Access Compliance Report

Public Rights-of-Way

Intersection ID: 51054	Main Street: MULBERRY_CHURCH_RD	Cross Street: N/A	Location: SE
ADA ID: 25F1F458C8E3	Ramp Type: Perp	Initial Pass/Fail: Fail	Overall Compliance: No
		Severity Score: 12.5

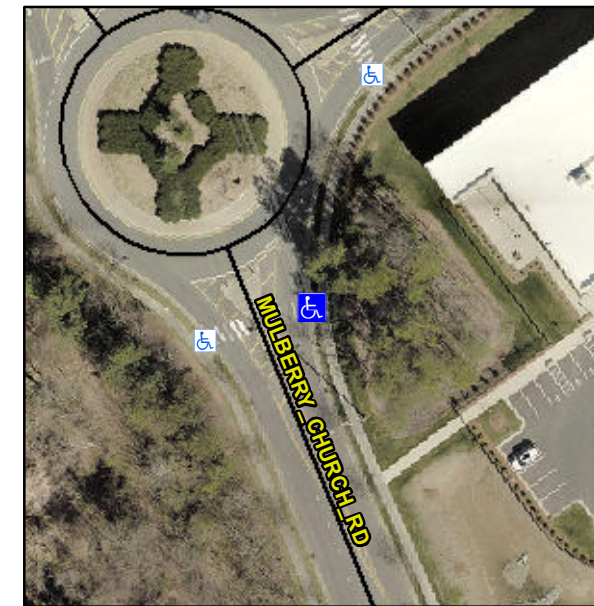
Not Found, R304.2.2

Compliance	Description	Data	Compliance	Description	Data
N/A	Ramp Length (in)	48.0	No	Ramp Slope (%)	8.8
Yes	Ramp Width (in)	48.0	Yes	Ramp XSlope (%)	0.8
N/A	Flare Type LT	N/A	N/A	Flare Type RT	N/A
N/A	Flare Slope LT (%)	N/A	N/A	Flare Slope RT (%)	N/A
N/A	Flare Traversable LT?	N/A	N/A	Flare Traversable RT?	N/A
N/A	Landing Length (in)	N/A	N/A	DWS Provided?	N/A
N/A	Landing Width (in)	N/A	N/A	DWS Contrast?	N/A
N/A	Landing Slope (%)	N/A	N/A	DWS Length (in)	N/A
N/A	Landing X Slope (%)	N/A	N/A	DWS Full Width?	N/A
N/A	Landing Curb? (Y/N)	N/A	N/A	DWS Offset (in)	N/A
N/A	Shared Landing?	N/A			
N/A	Gutter Ponding?	N/A	N/A	Gutter Slope (%)	N/A
N/A	Gutter Lip Ht (in)	N/A	N/A	Gutter X Slope (%)	N/A
N/A	Painted X Walk1?	Yes	N/A	Painted X Walk2?	N/A
	X Walk 1 Direction	To W		X Walk 2 Direction	N/A
N/A	X Walk 1 Width (in)	116.0	N/A	X Walk 2 Width (in)	N/A
	X Walk 1 Slope (%)	2.2		X Walk 2 Slope (%)	N/A
	X Walk 1 X Slope (%)	2.7		X Walk 2 X Slope (%)	N/A

Remove & Replace Entire Ramp.
